Staff Report

5a Repairs of two stories wrap porch, including frame, columns and deck boards. New wood stoops and steps for the back side of the house-
#1017 Eaton Street - David Knoll (H11-01-1409)

APPLICATION # 11-01-1409

Sheet
A1
 of 2 sheets

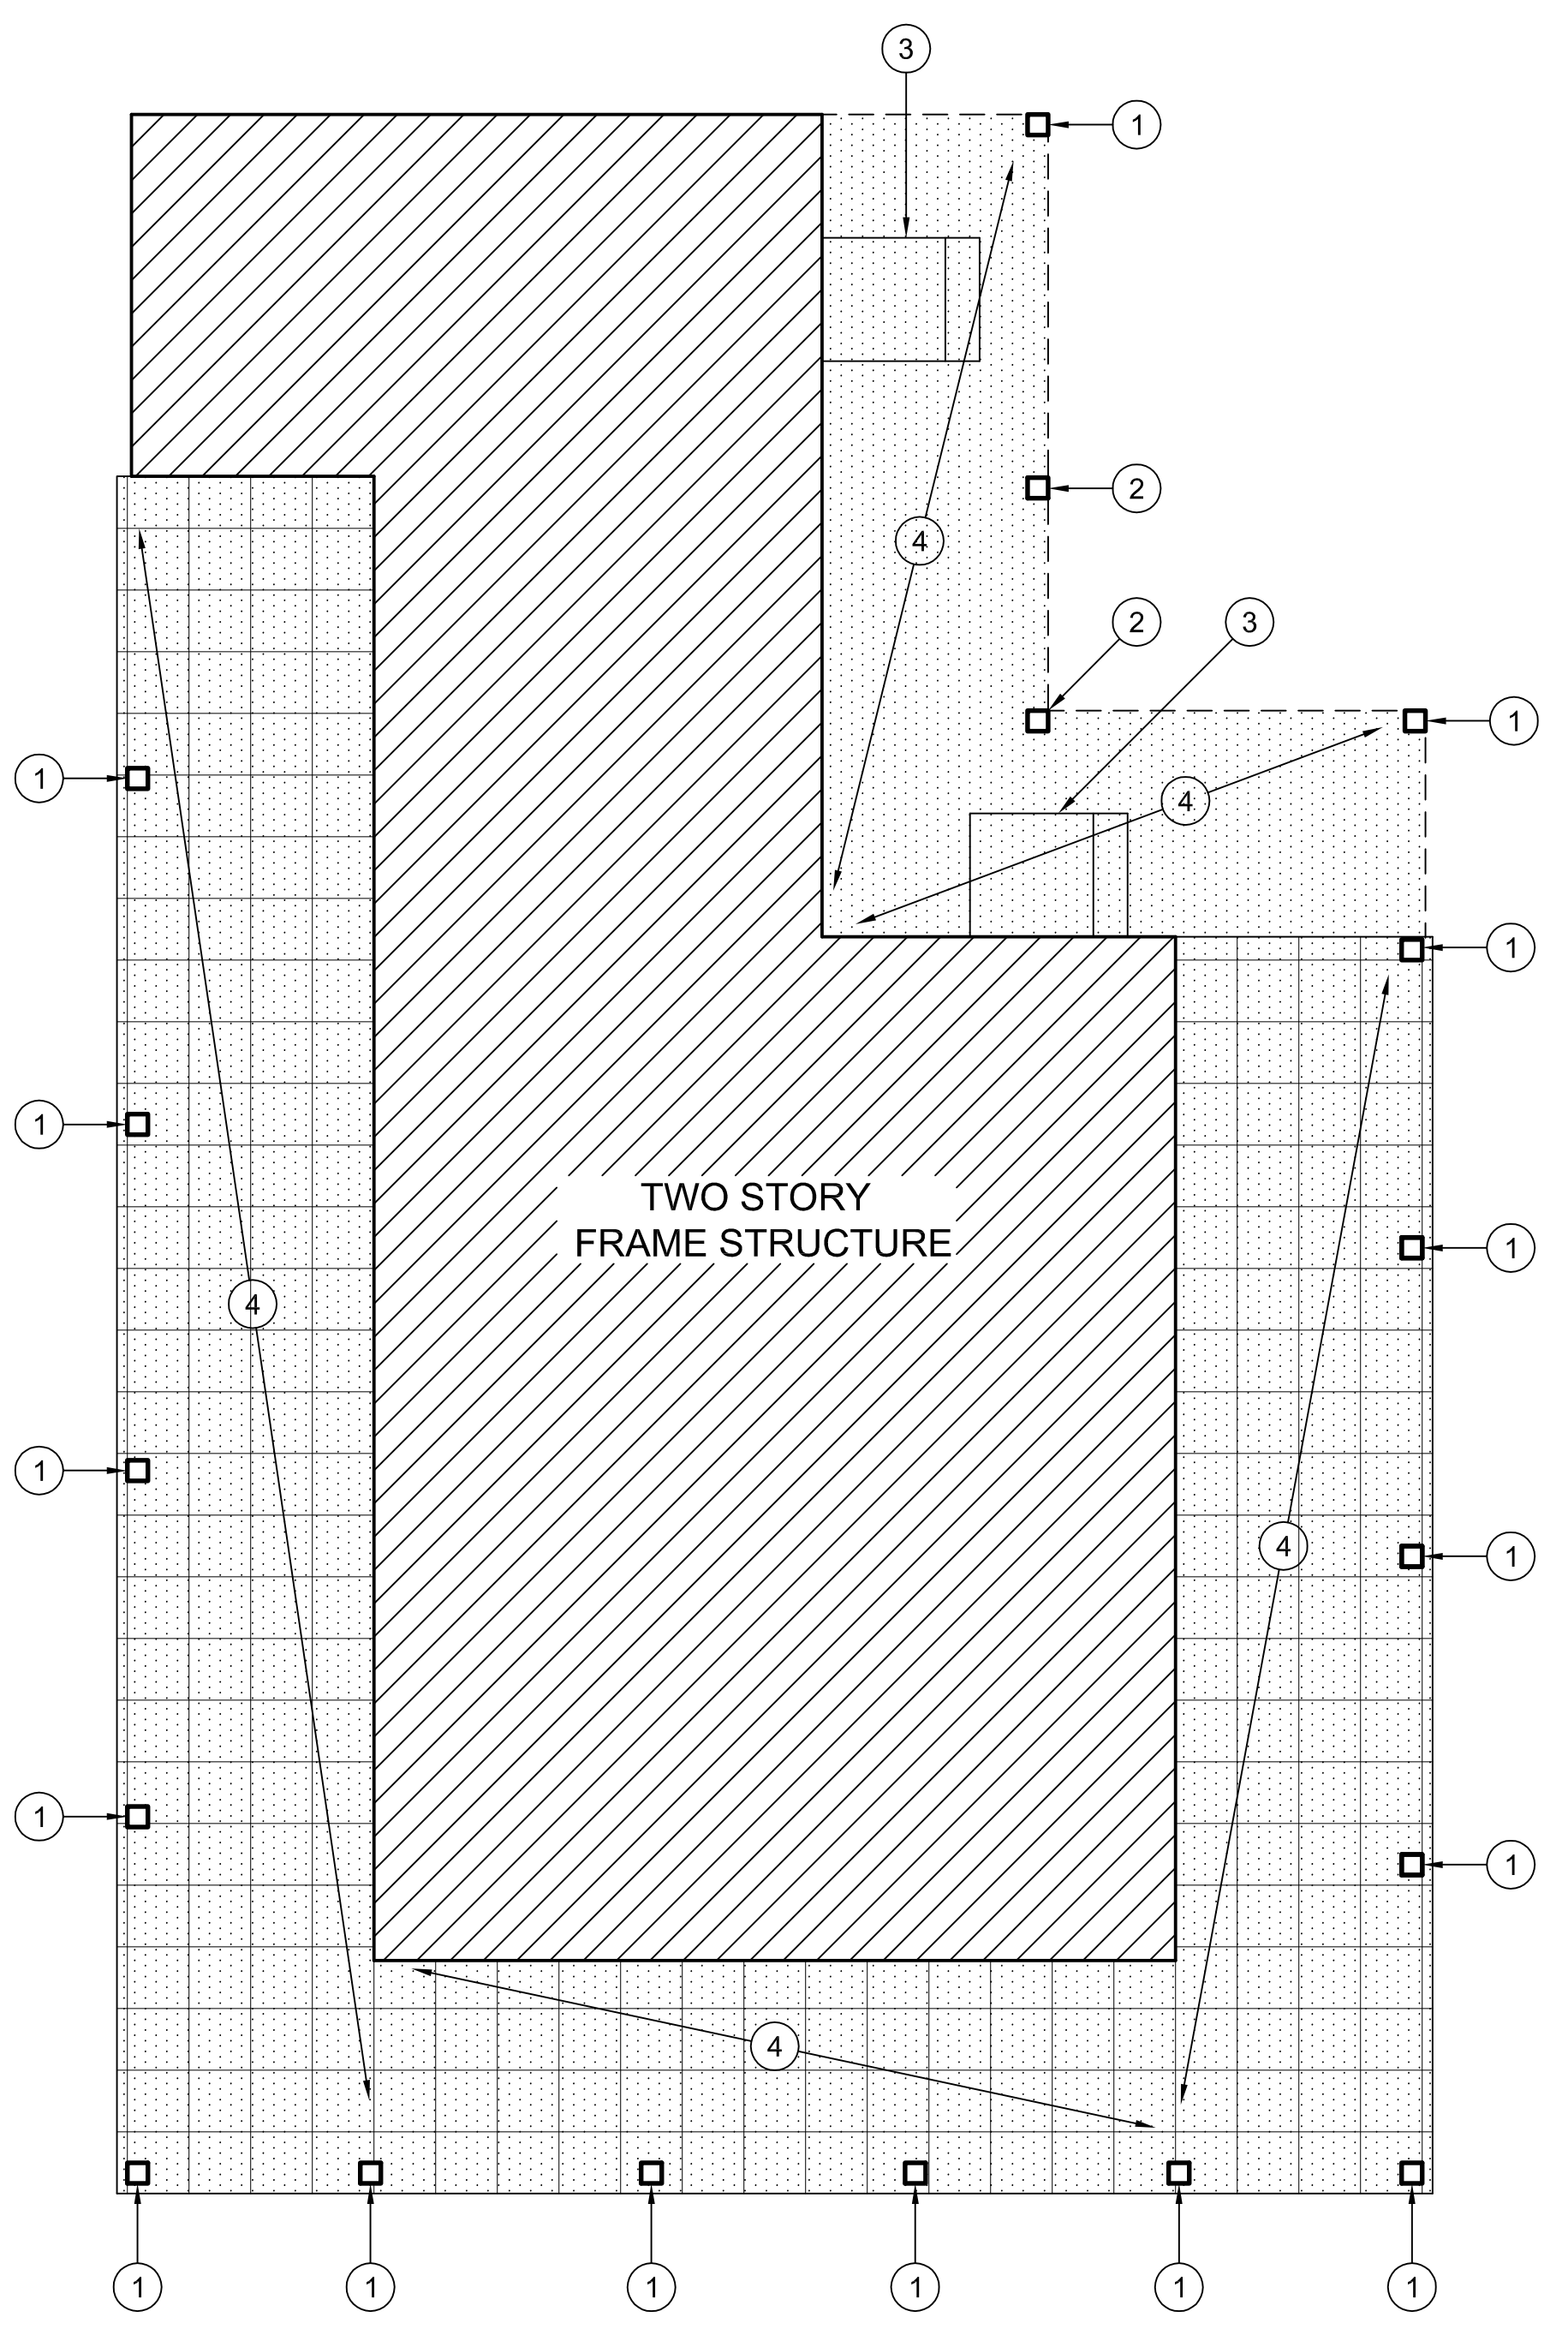
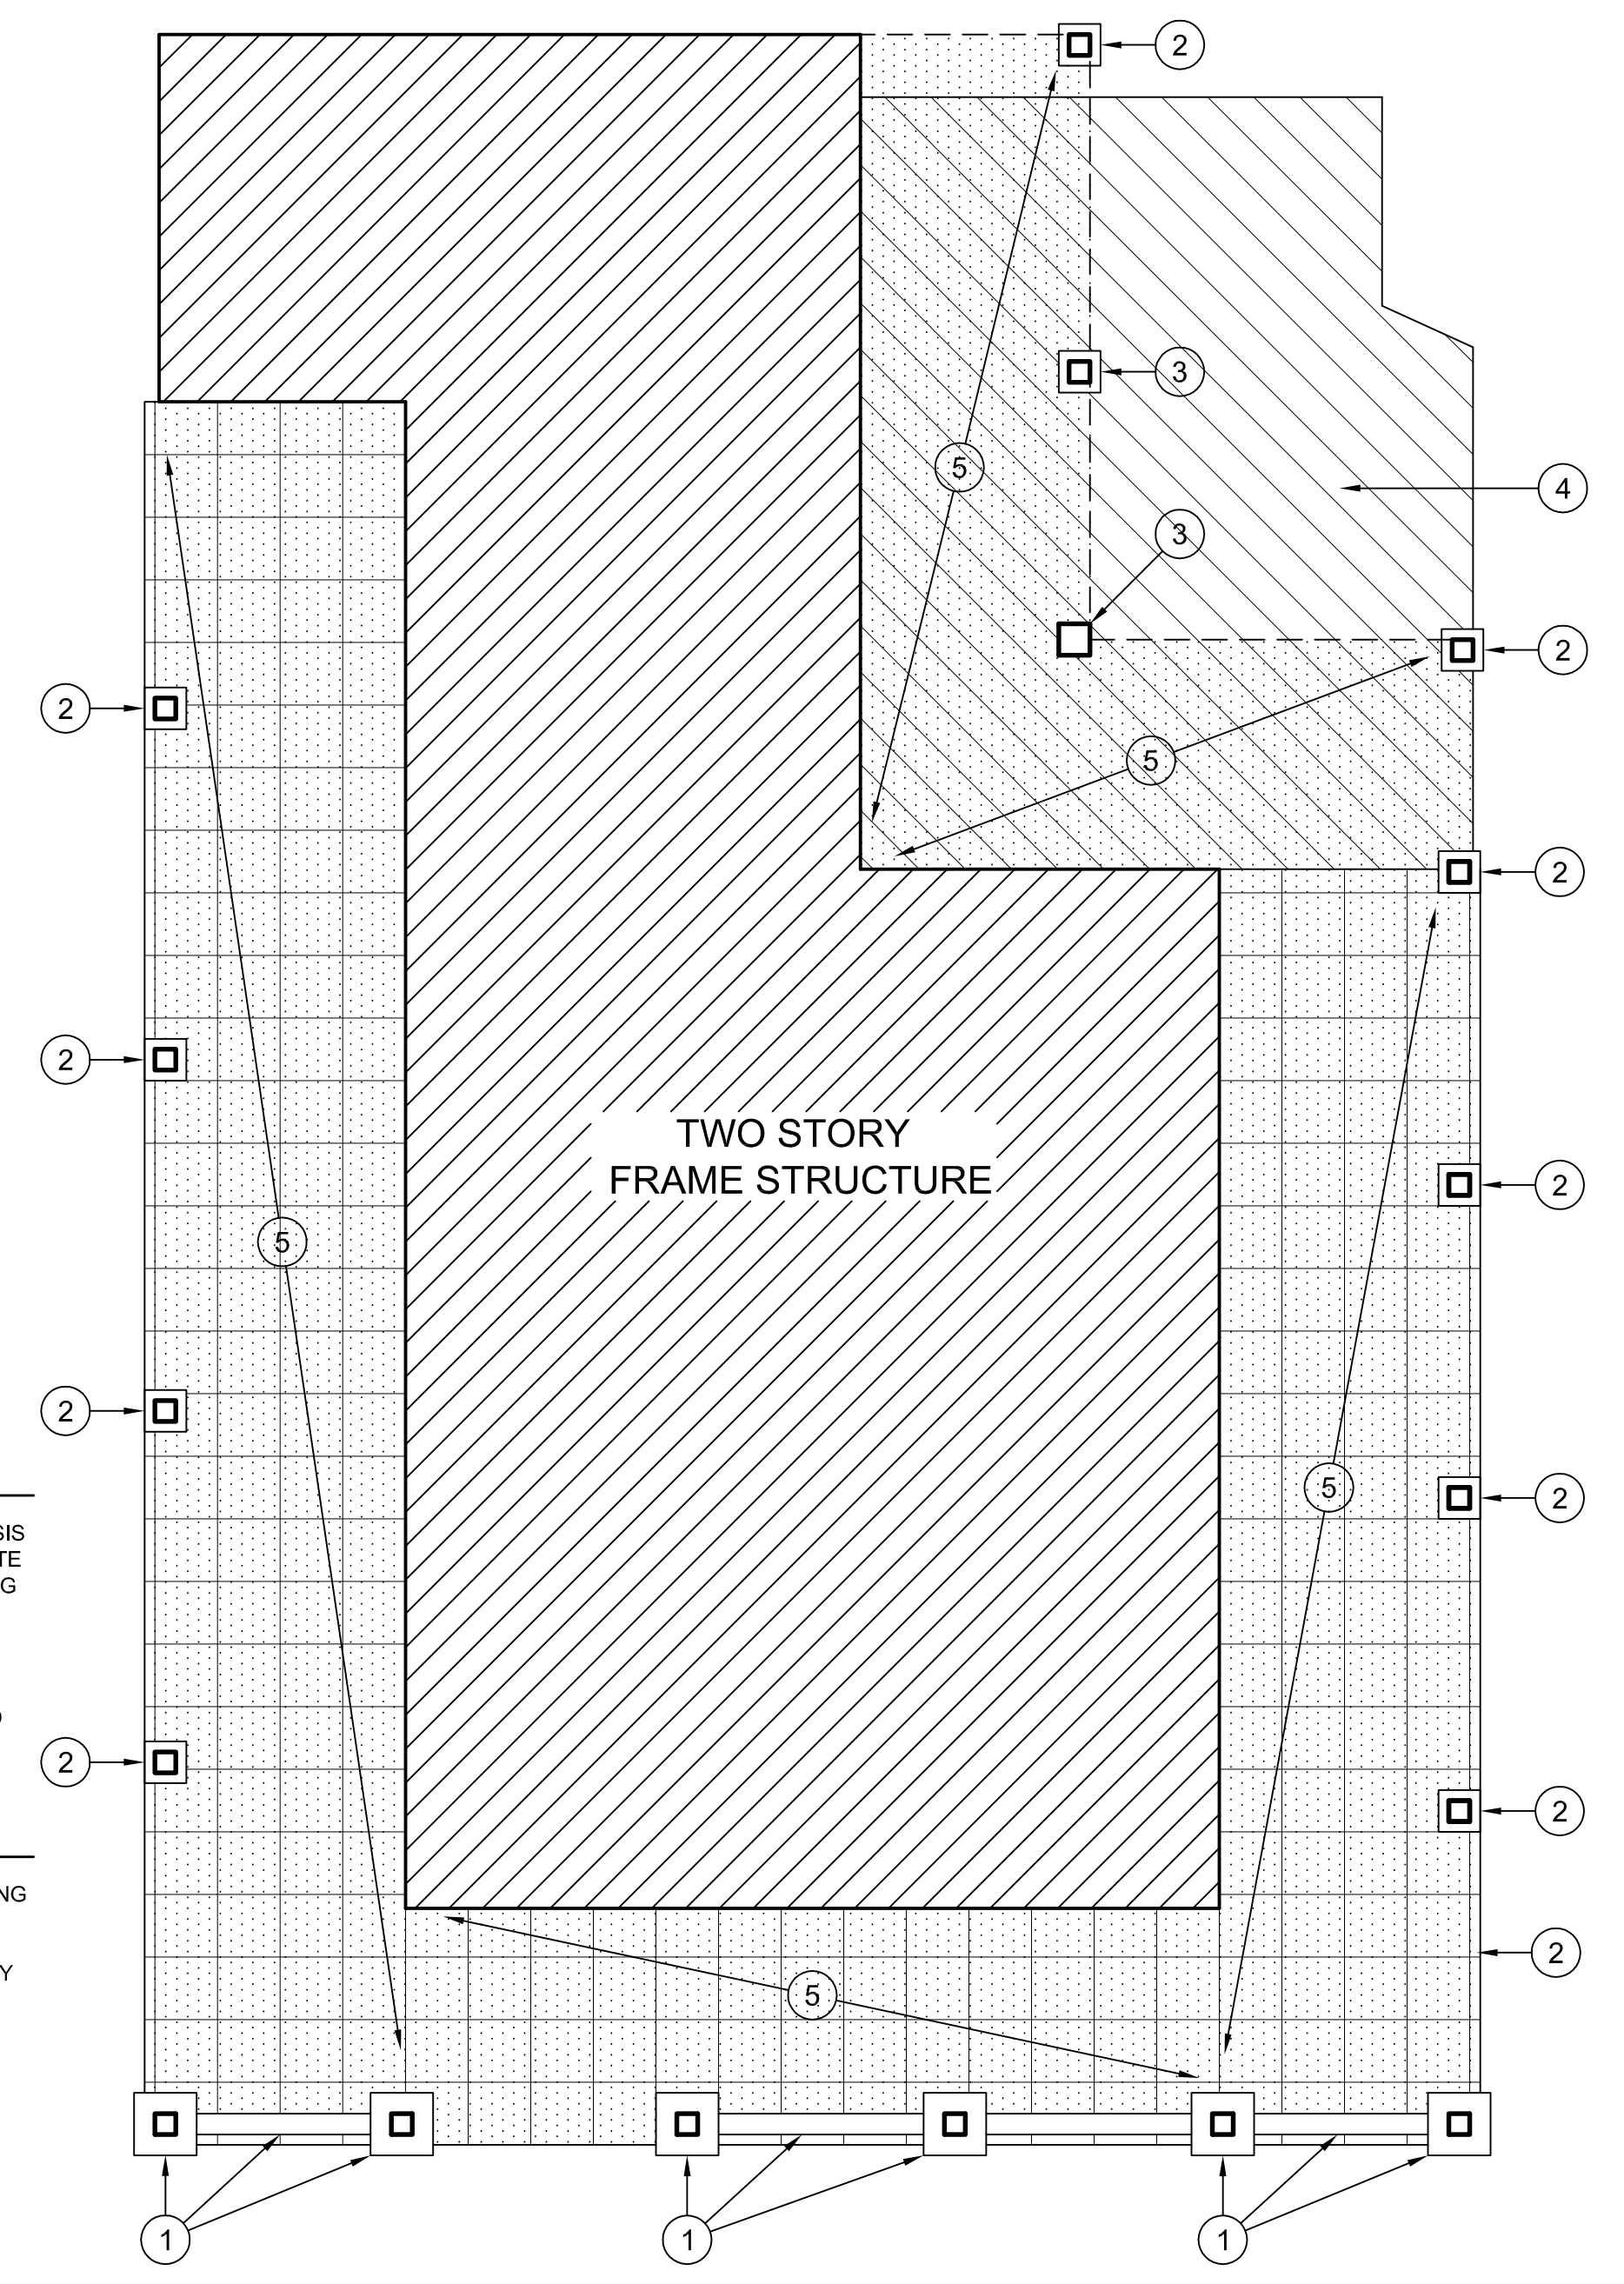
It is staff's belief that the proposed plans are consistent with the guidelines. Understanding that at this point there is not enough documentation as to the extent of the structural integrity of the existing columns, it is staff's belief that plans showing which columns will need to be replaced must be submitted for final approval. All new replaced elements will be made of wood. Staff understands that the proposed wood steps on the northeast side of the house will not have any effect on the historic site.
